PROJECT: Ferndale Terrace Project

City Project SW2016-01; TIB Project Number 8-2-985(011)-1

**ADDENDUM NO. 3**  
To the Contract Documents for:  
City of Ferndale, Washington  
FERNDALE TERRACE PROJECT  
City of Ferndale Project No. SW2016-01; TIB Project Number 8-2-985(011)-1

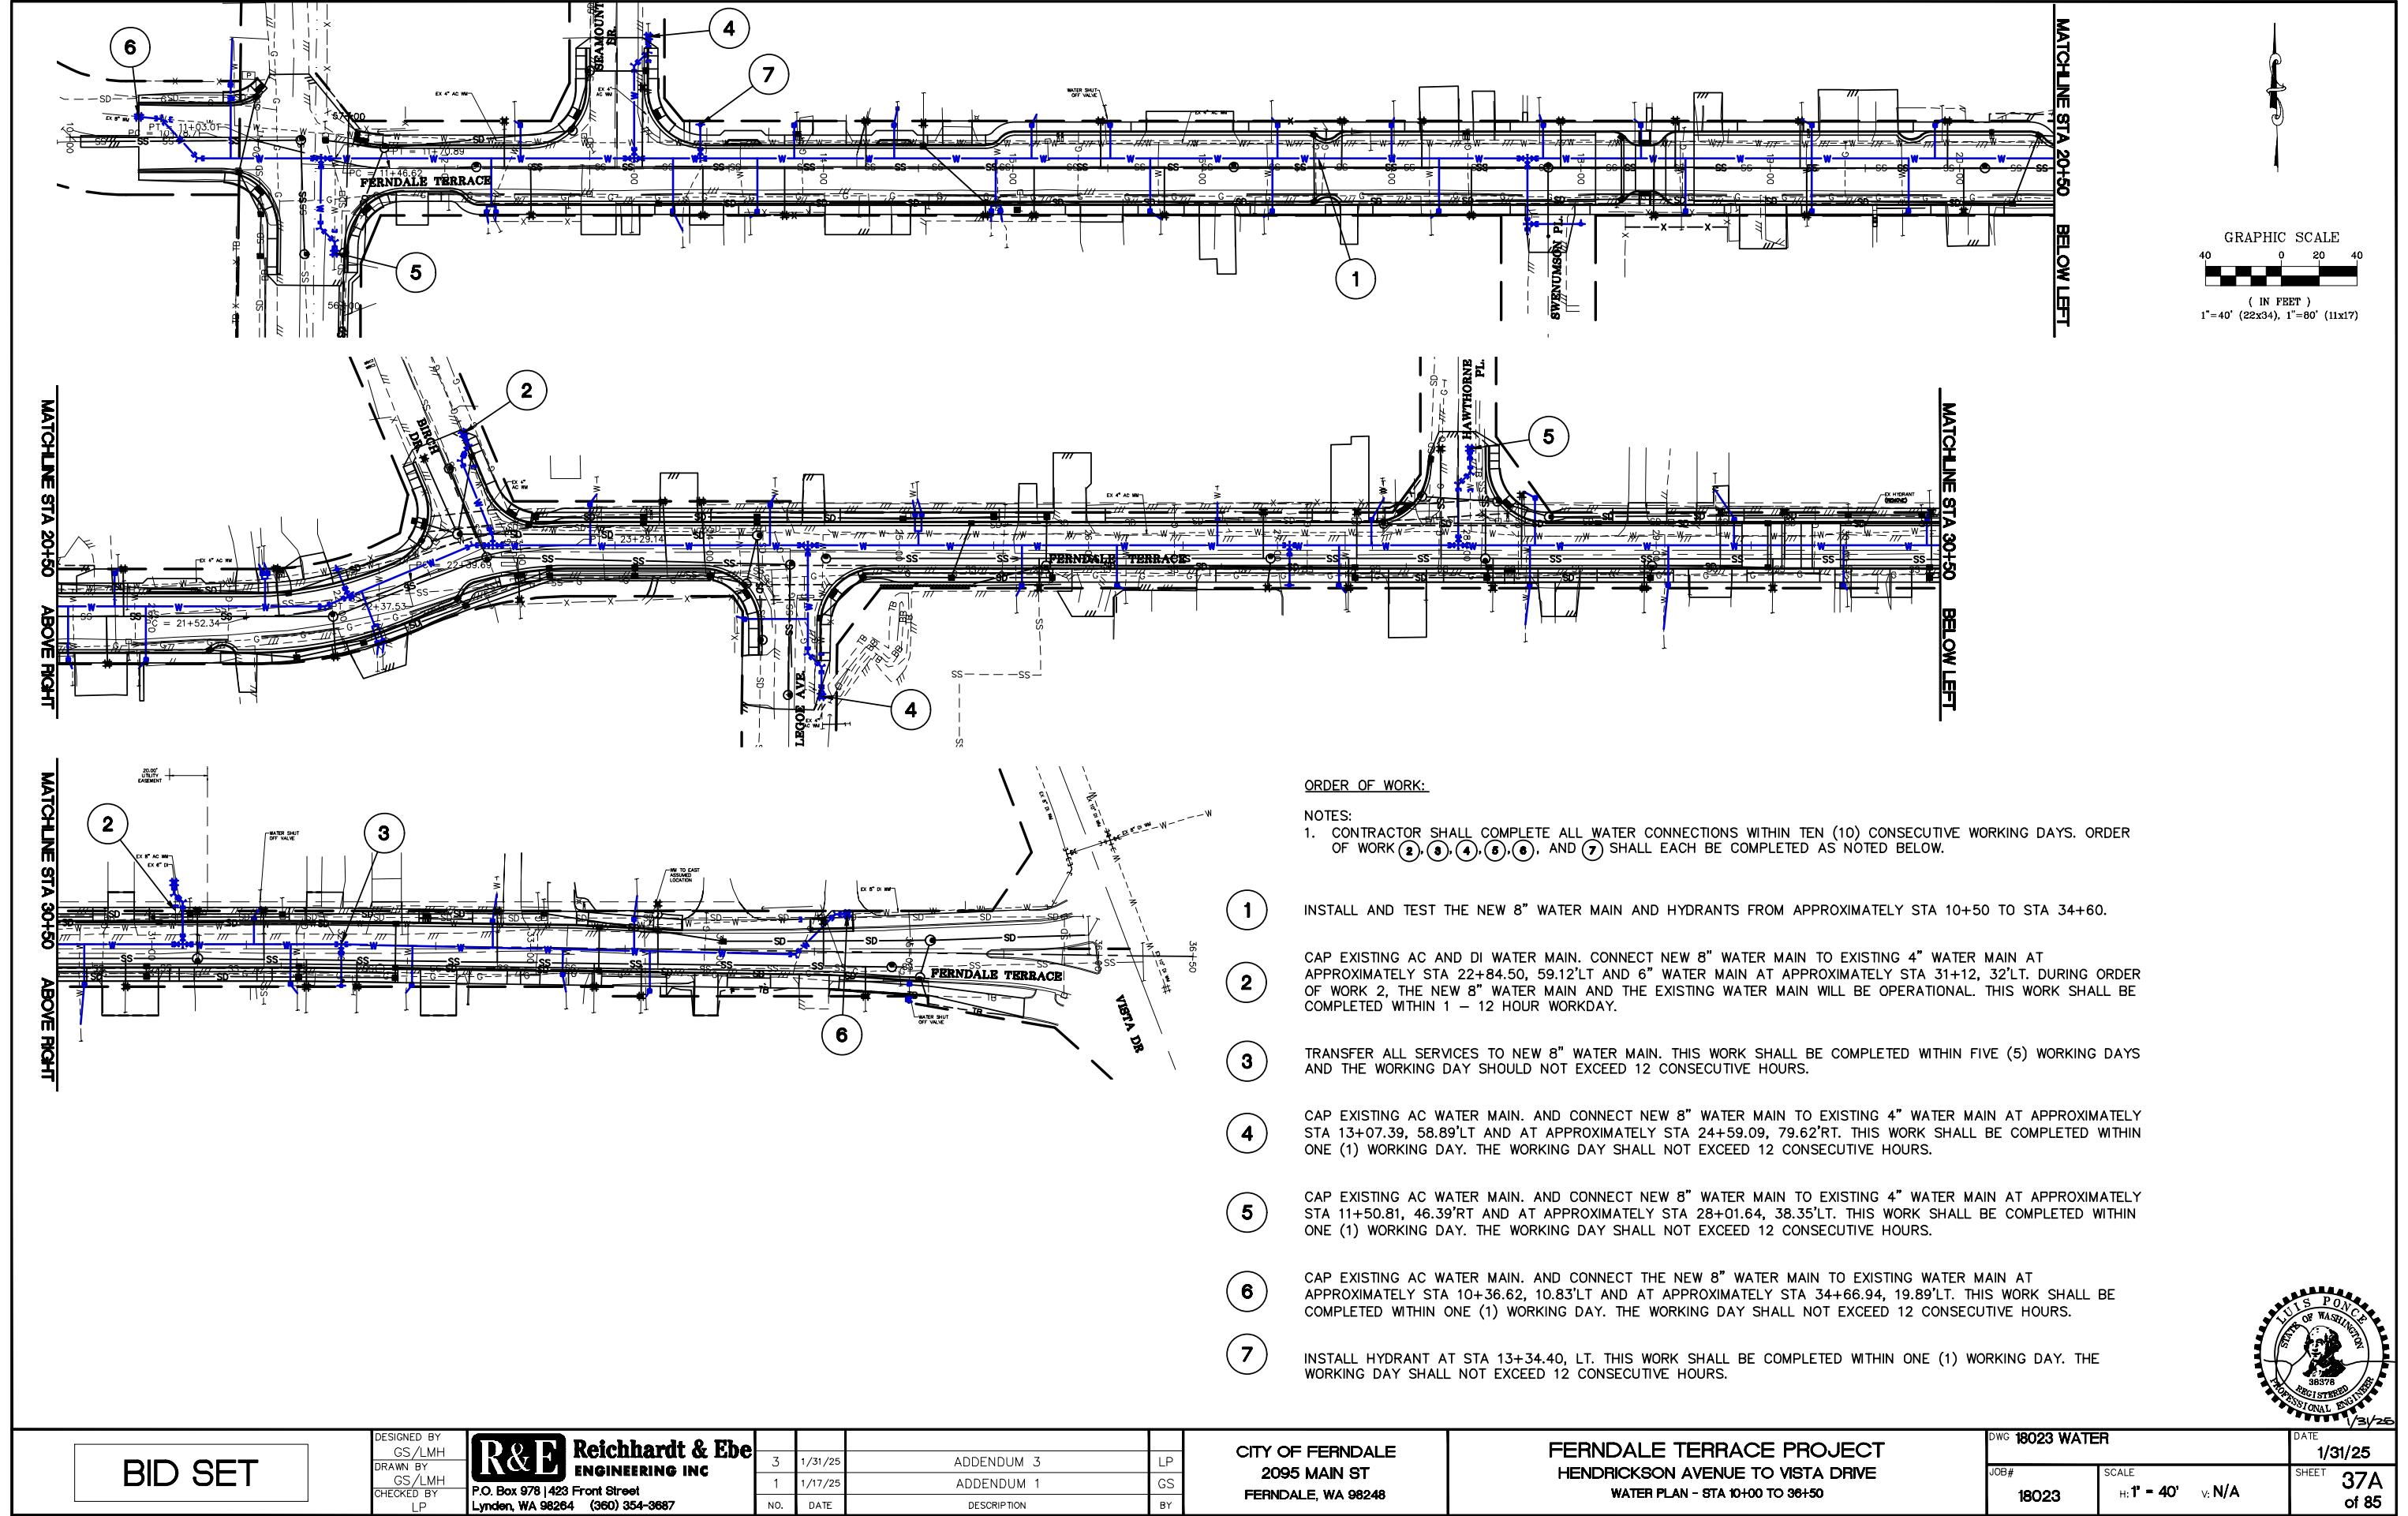
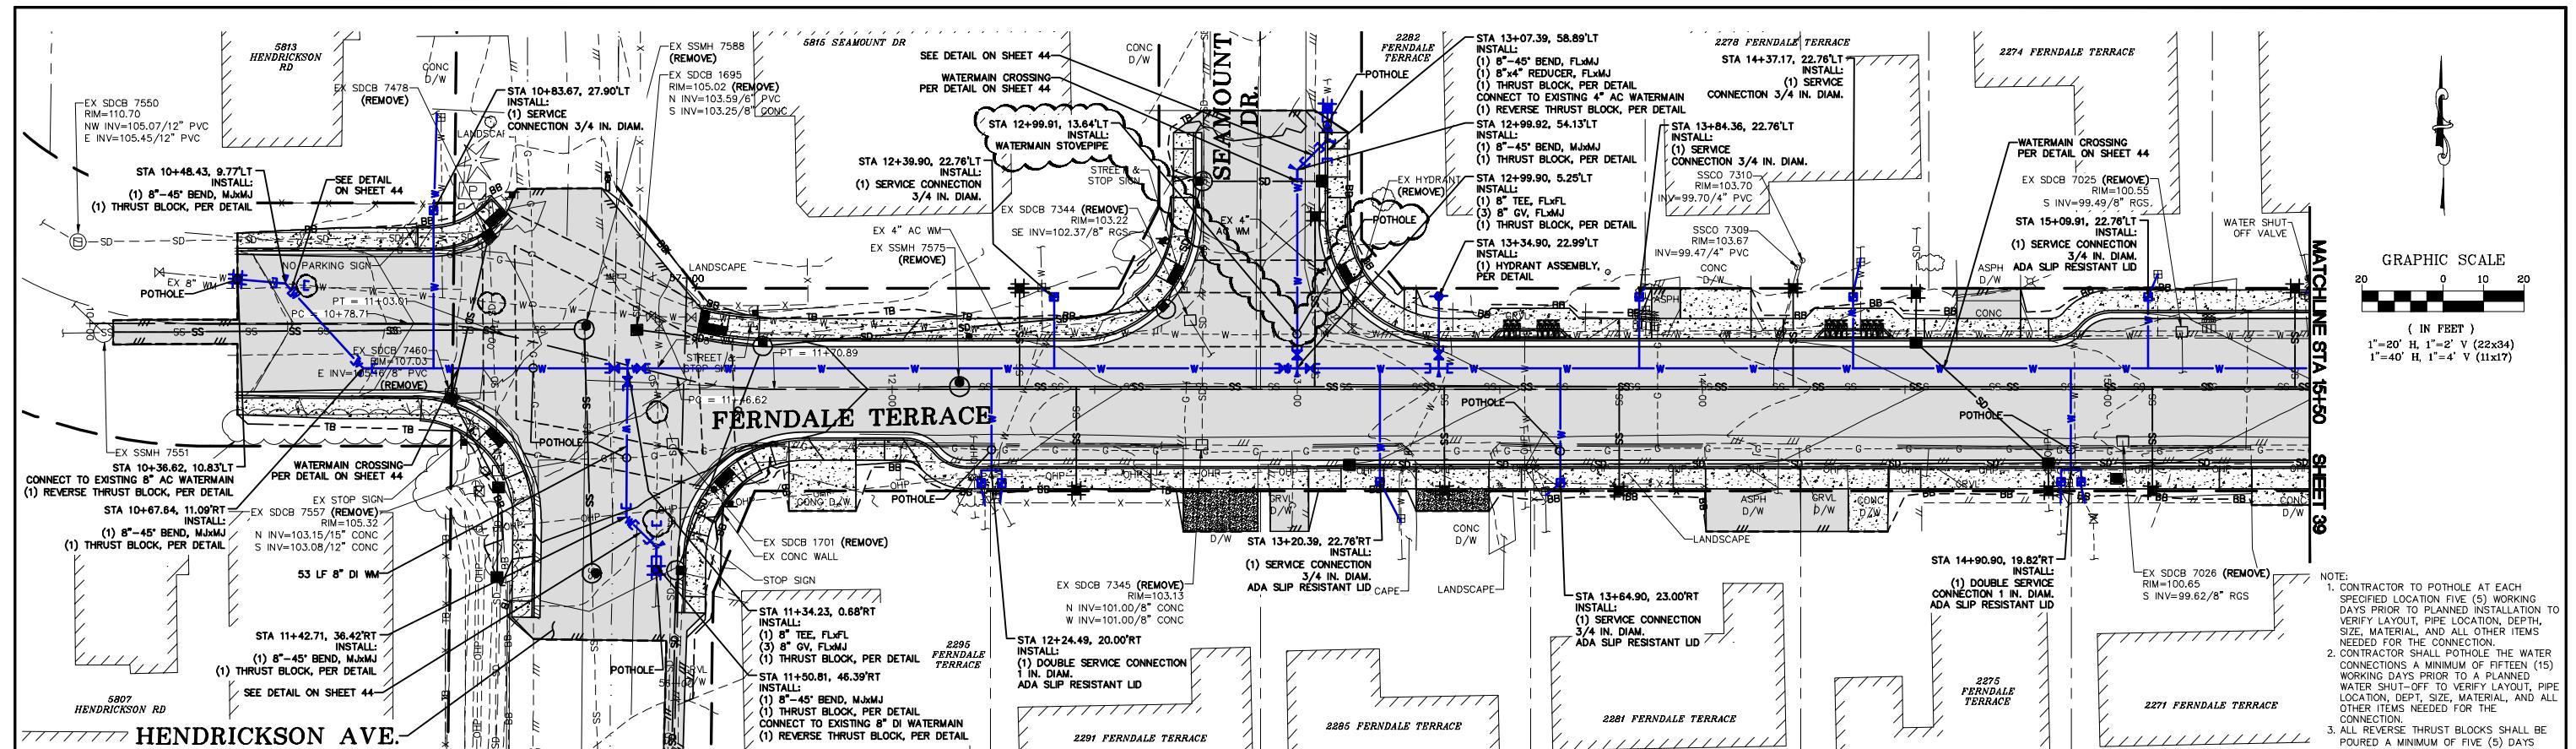
Sheet 33, SS cleanout at approximately STA 25+40, RT, was deleted.

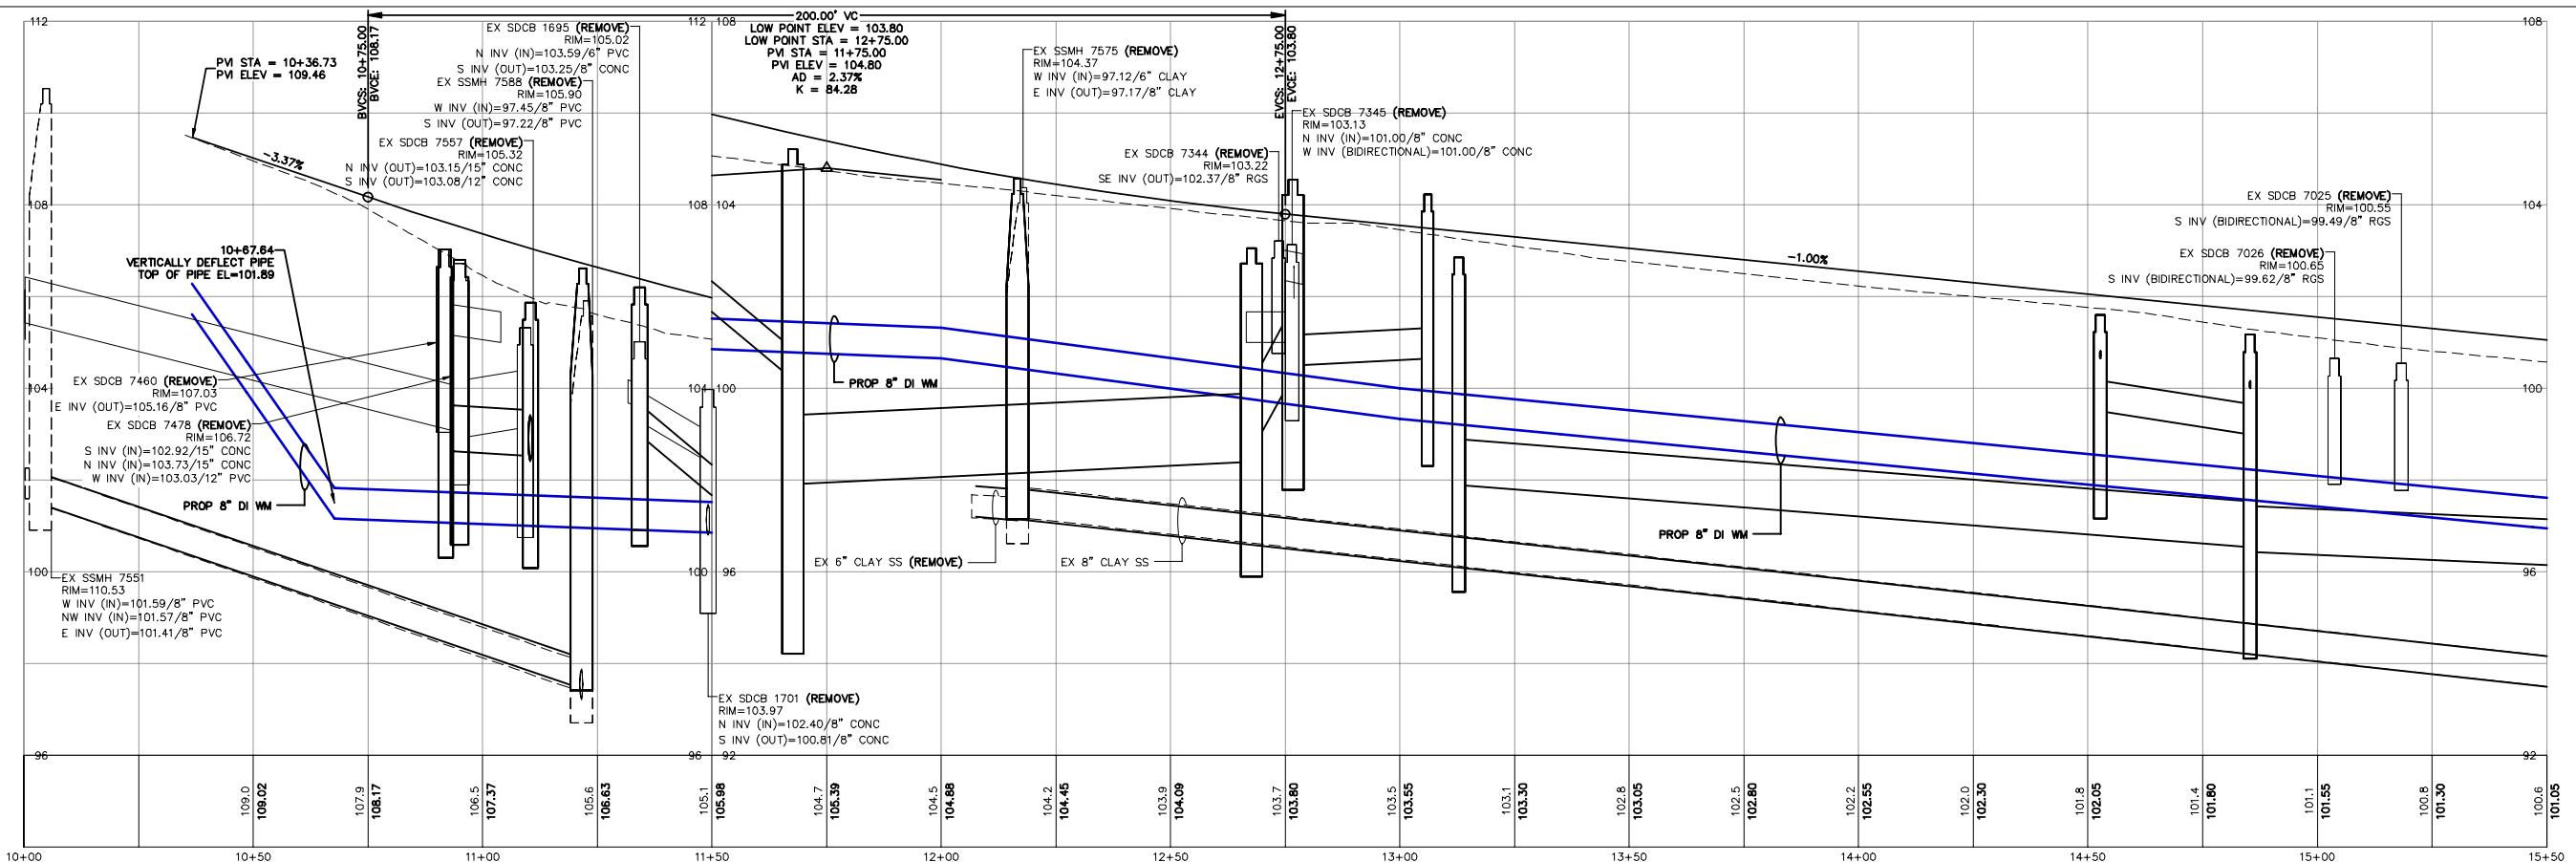
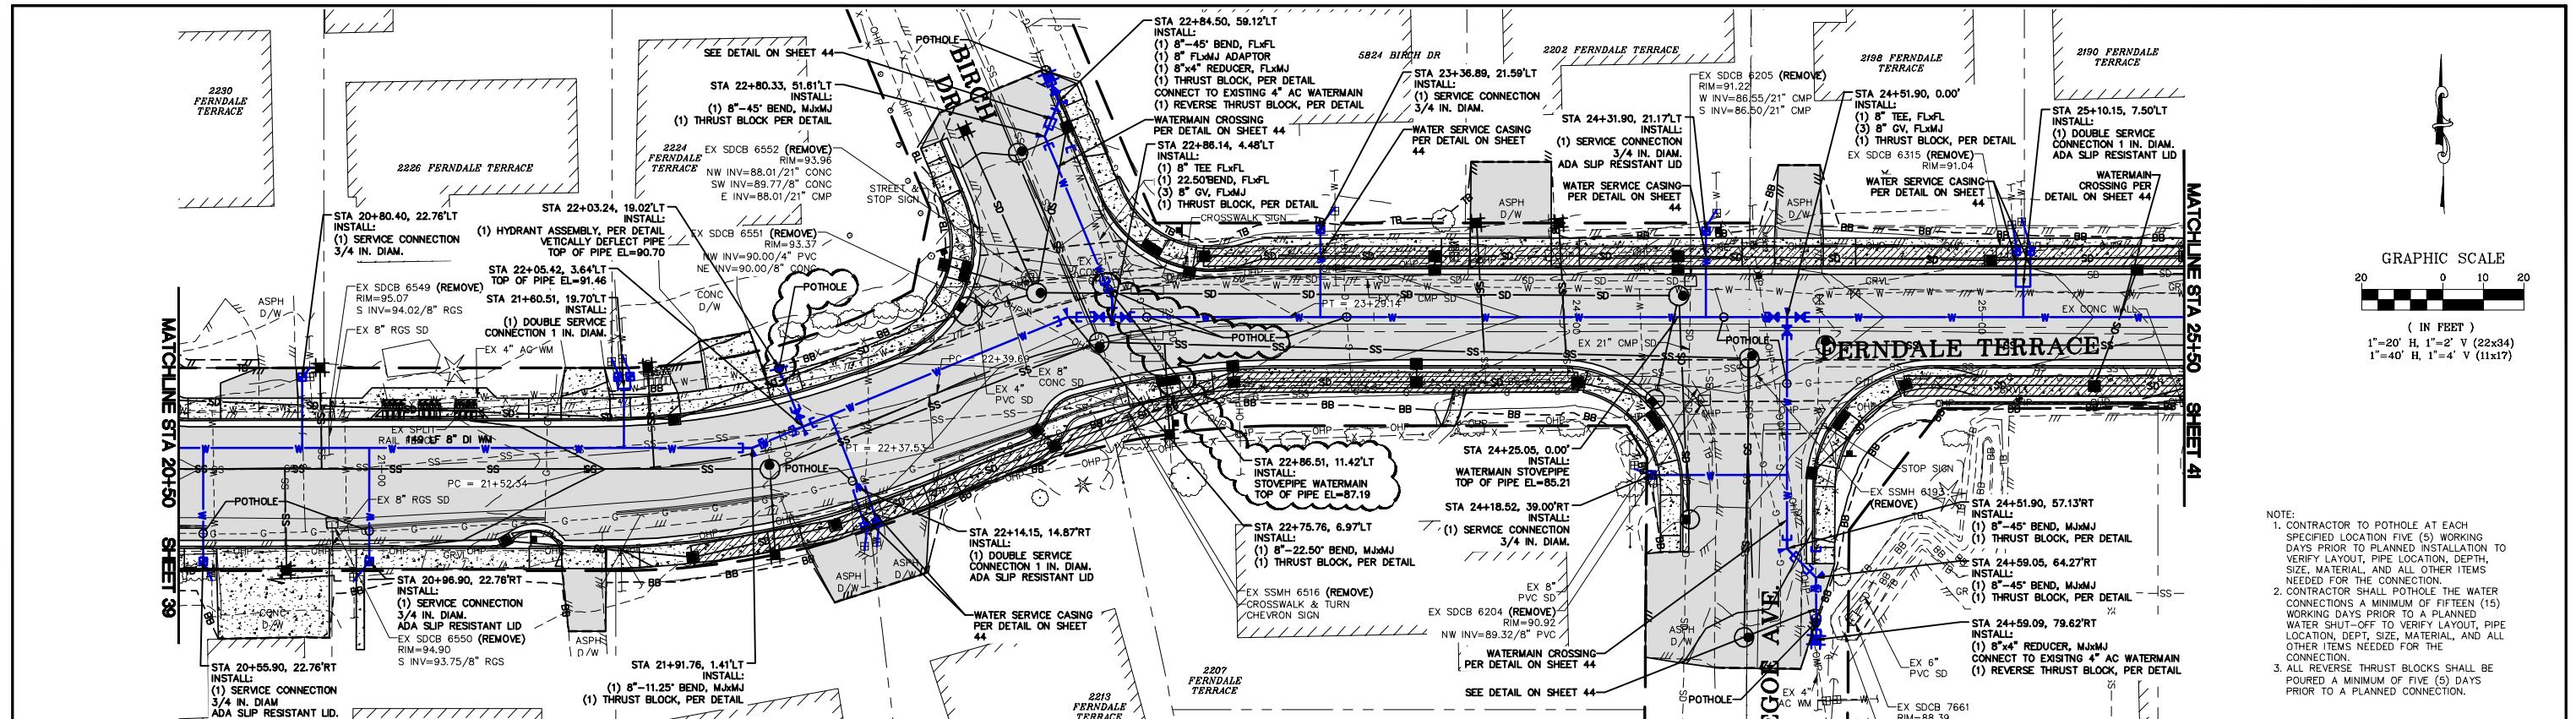
Sheet 38, water main caps at approximately STA 10+97, LT and STA 11+45, RT are deleted as Order of Work Sheet 37A revises water main cap locations. Watermain stovepipe and pothole callouts added at STA 12+99.91, LT.
